FILE # # G-17591

PUBLIC INTEREST REVIEW FOR GROUND WATER APPLICATIONS

TO: Water Rights Section Date 12/14/2012
 FROM: Ground Water/Hydrology Section Jen Woody
 SUBJECT: Application G- 17591 Reviewer's Name Jen Woody
 Supersedes review of n/a Date of Review(s) _____

A. GENERAL INFORMATION: Applicant's Name: Boyd Family 2001 Trust County: Jackson

Transient Stream Depletion (Jenkins, 1970; Hunt, 1999, 2003)
JACK 61302

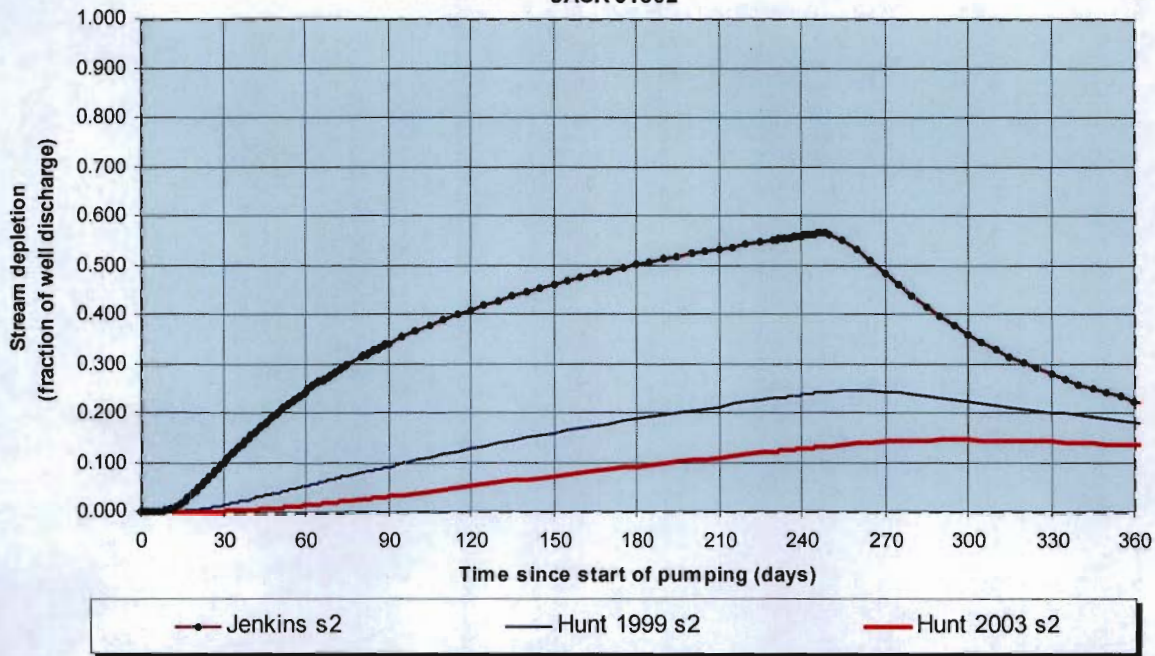
Comments: Site specific aquifer parameters are not available, but using a range of textbook values for fractured granitic materials and multiple stream depletion models, stream depletion at 30 days ranges from 0.18% (Hunt 2003) to 9.9% (Jenkins). The Jenkins results is overly conservative, but it does not trigger a PSI finding.
